PROPOSED CONCEPT PLAN: OPTION 1

SURVEY 2 FEEDBACK: CONCEPT PLAN 1

PROPOSED CONCEPT PLAN: OPTION 1 REVISED

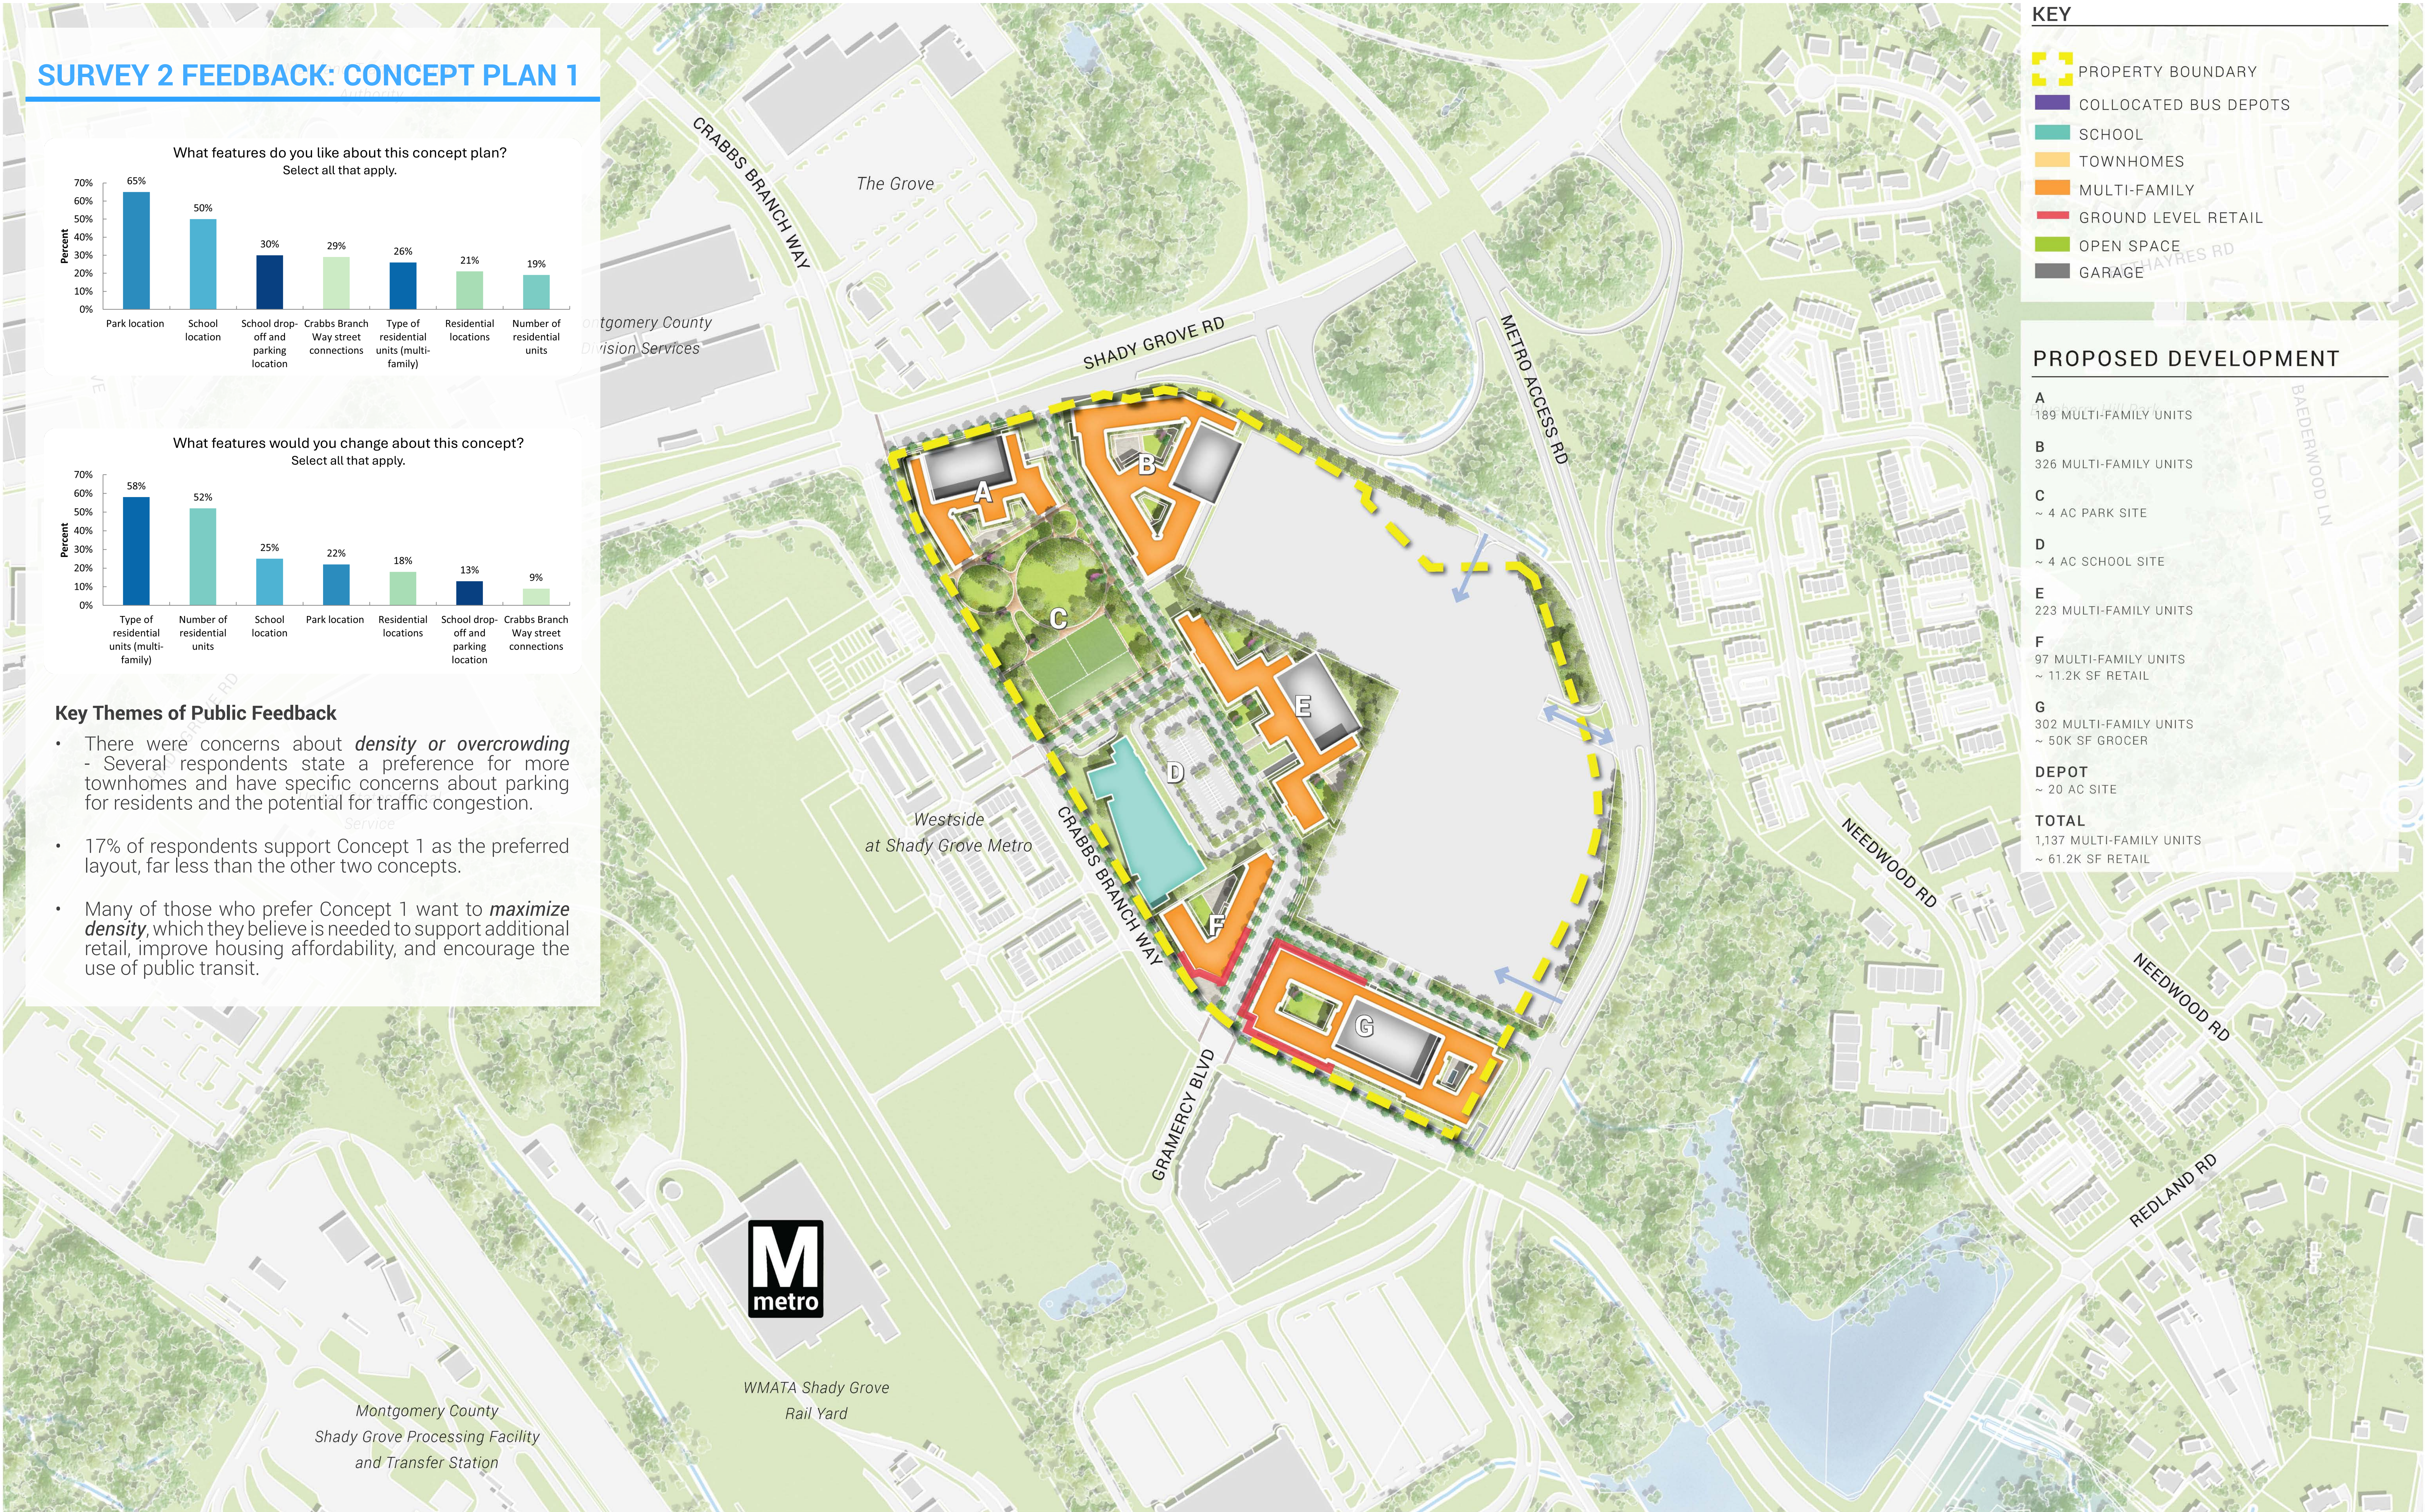
- There were concerns about **density or overcrowding** - Several respondents state a preference for more townhomes and have specific concerns about parking for residents and the potential for traffic congestion.
- 17% of respondents support Concept 1 as the preferred layout, far less than the other two concepts.
- Many of those who prefer Concept 1 want to **maximize density**, which they believe is needed to support additional retail, improve housing affordability, and encourage the use of public transit.

- Townhomes are added in Blocks A and D. Multi-Family buildings are removed from Blocks A, B, and E and expanded in Blocks F and G.
- The bus depot is shifted northwest, closer to Shady Grove Road and farther away from Crabbs Branch Way.
- The park is reoriented to be a linear buffer between the community and the bus depot.
- The school is relocated to Block C, improving access by the larger community, while remaining relatively central to the proposed development.
- Parking counts, both on-street and off-street, are included in Proposed Development.

PROPOSED CONCEPT PLAN: OPTION 2

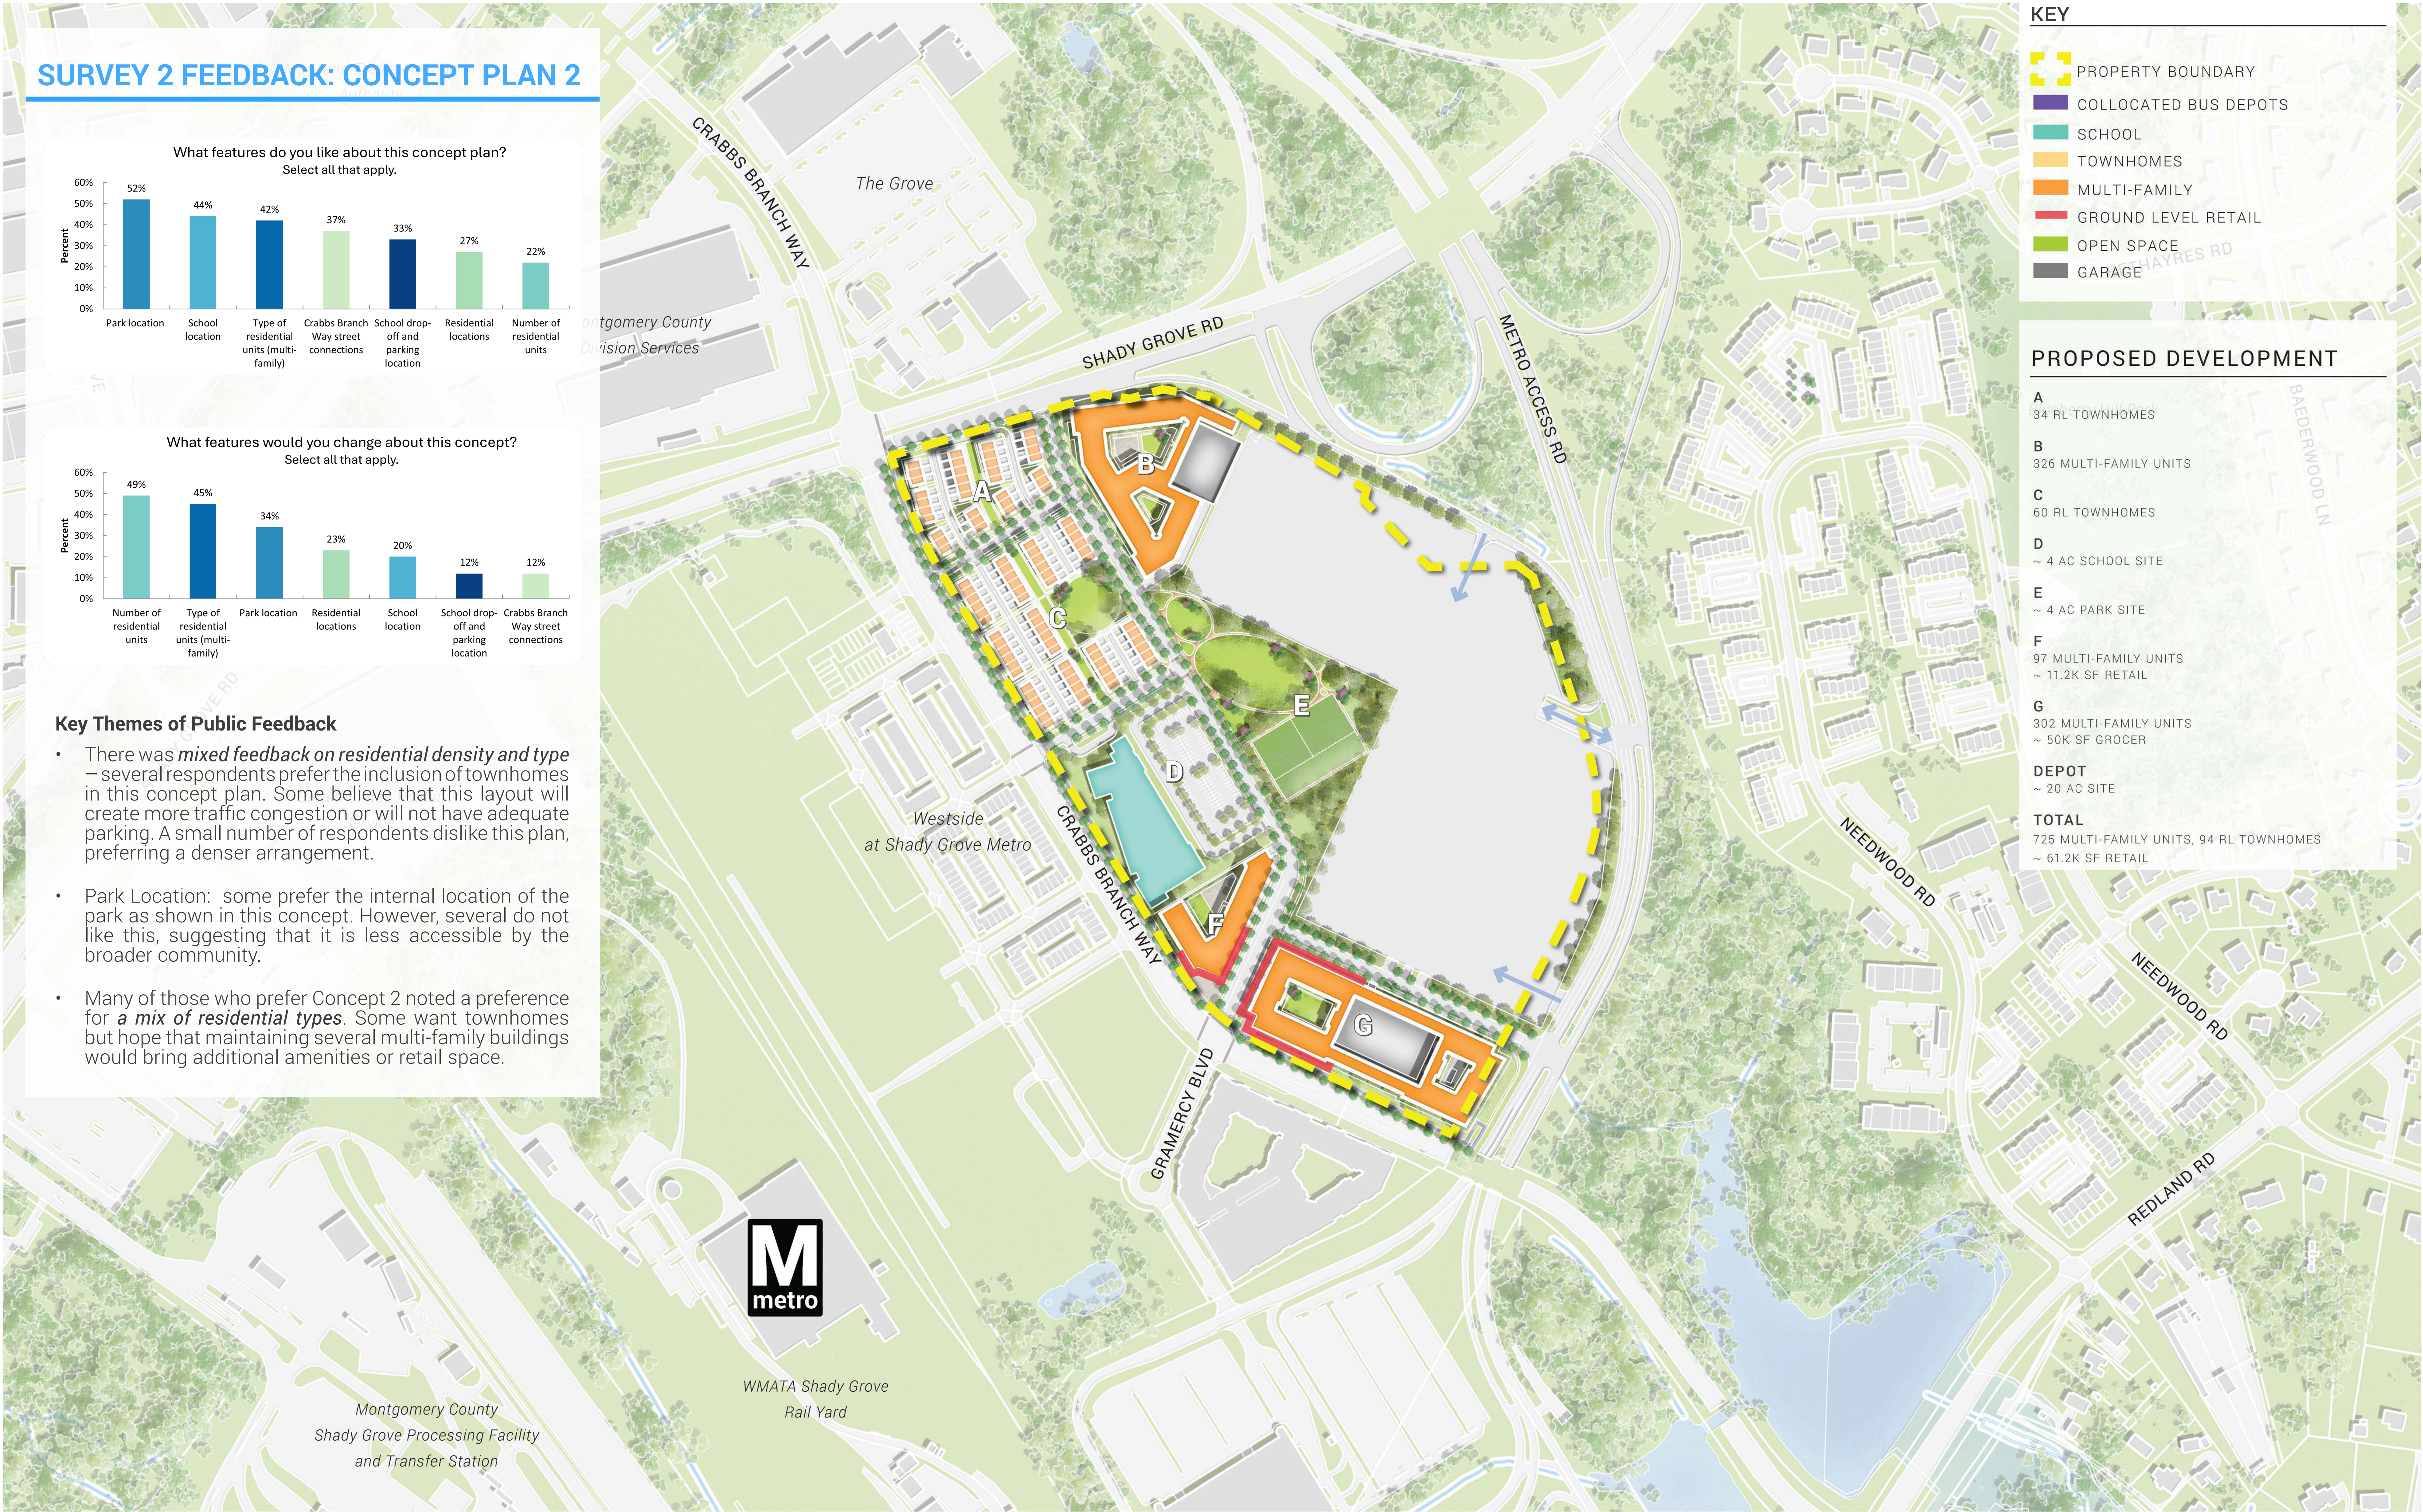
- There was *mixed feedback on residential density and type* – several respondents prefer the inclusion of townhomes in this concept plan. Some believe that this layout will create more traffic congestion or will not have adequate parking. A small number of respondents dislike this plan, preferring a denser arrangement.
- Park Location: some prefer the internal location of the park as shown in this concept. However, several do not like this, suggesting that it is less accessible by the broader community.
- Many of those who prefer Concept 2 noted a preference for *a mix of residential types*. Some want townhomes but hope that maintaining several multi-family buildings would bring additional amenities or retail space.

- 30% of respondents on Survey 2 responded that Block E was their preferred school location, though none of the previous concepts showed that.
- The locations of the park and school were flipped, with the park now in Block D, closer to Crabbs Branch Way, and the school in Block E, helping to buffer the bus depot and lessen school bus traffic on Crabbs Branch Way.
- Parking counts, both on-street and off-street, are included in Proposed Development.
